77.3.3.2 Variables

77.3.3.5 State diagram

Figure 77–23—Discovery Processing ONU Registration state diagram

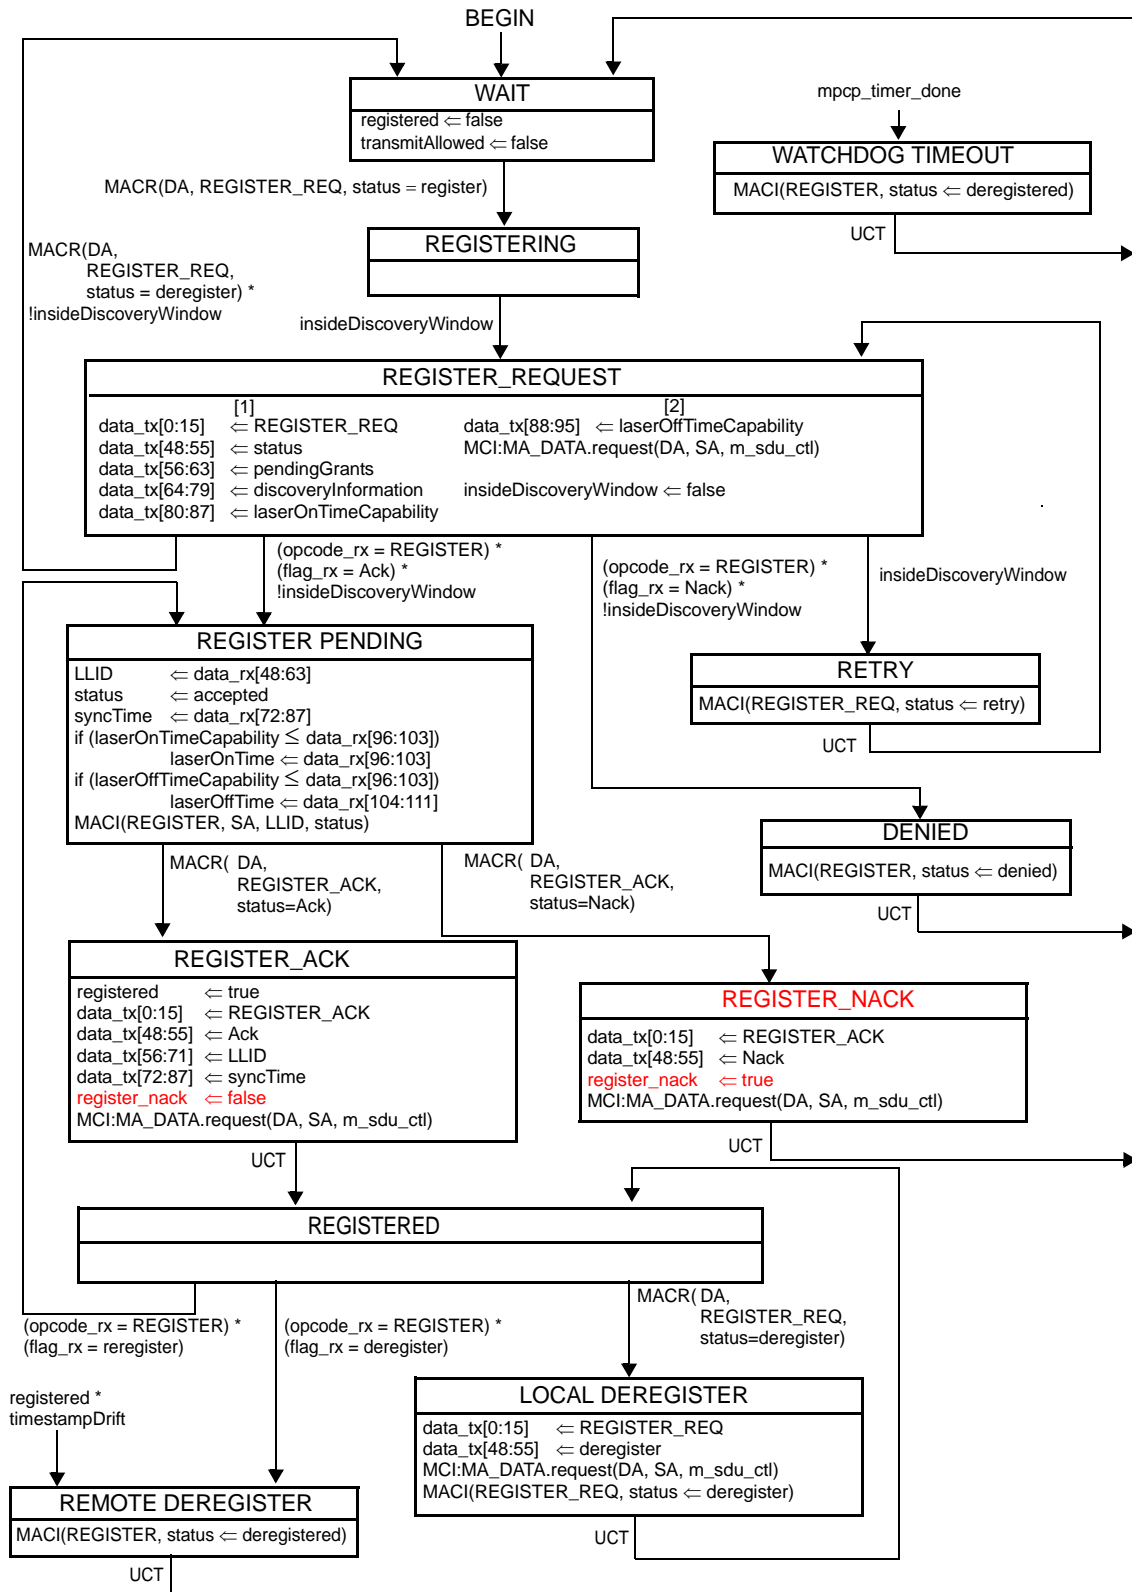
This variable indicates whether registration was denied by ONU DBA client. It is set to true in NACK state in [Figure 77-23](#) and set to false in REGISTER_ACK state in [Figure 77-23](#).

Replace Figure 77-23 with Figure 77-23 presented below

Figure 77–29—Gate Processing ONU Programming state diagram

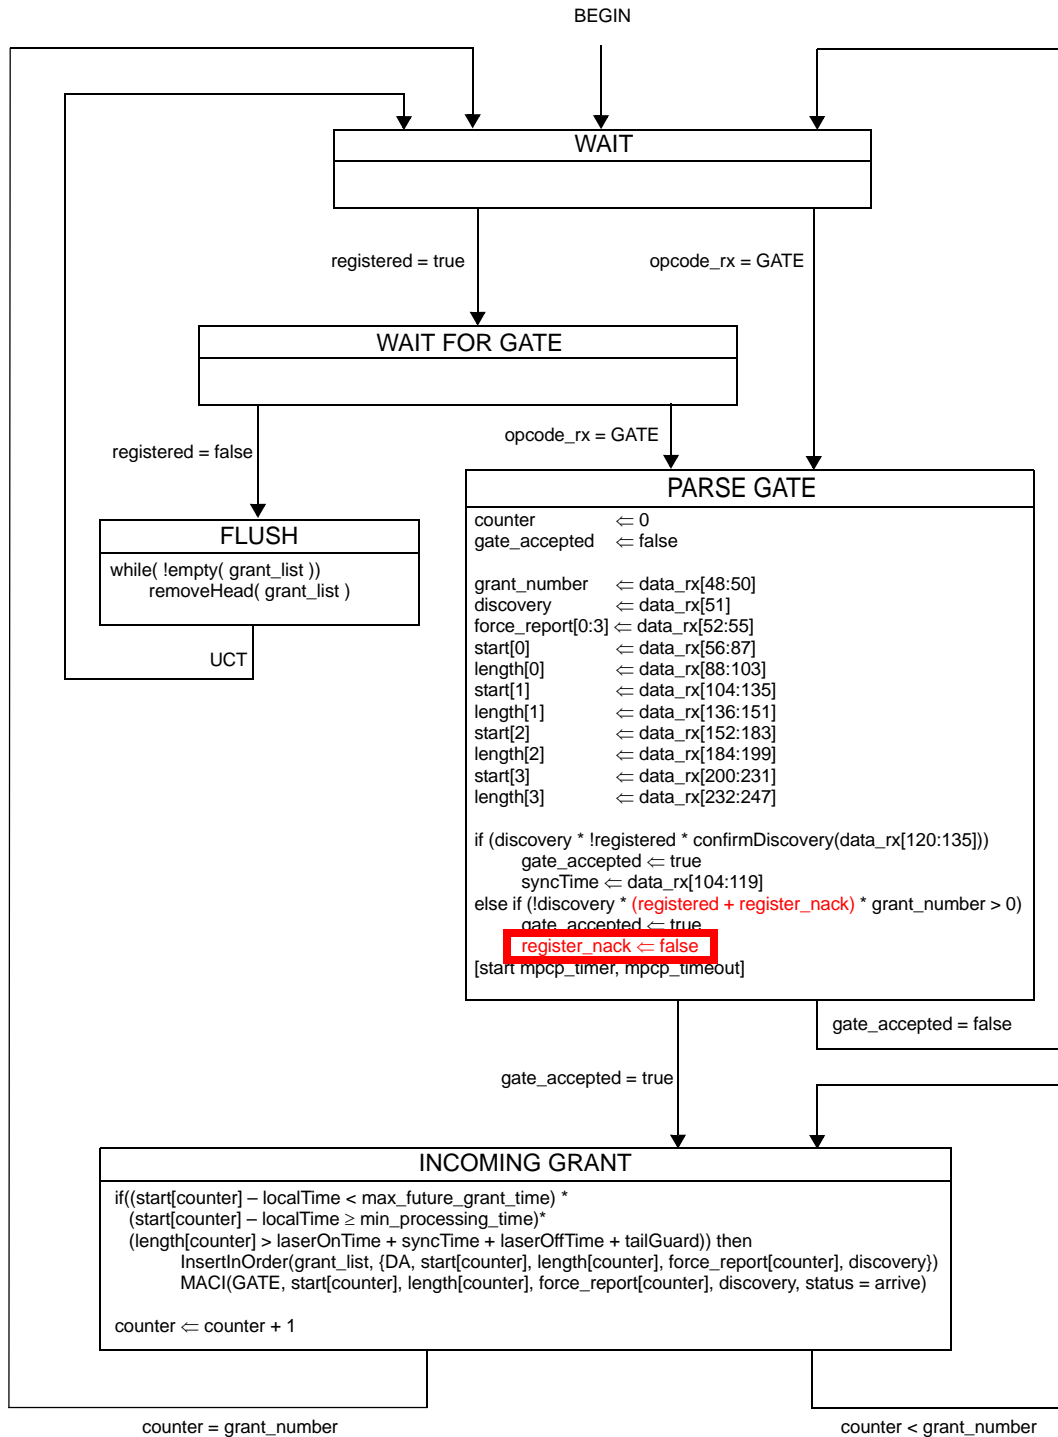
Replace Figure 77-29 with Figure 77-29 presented below
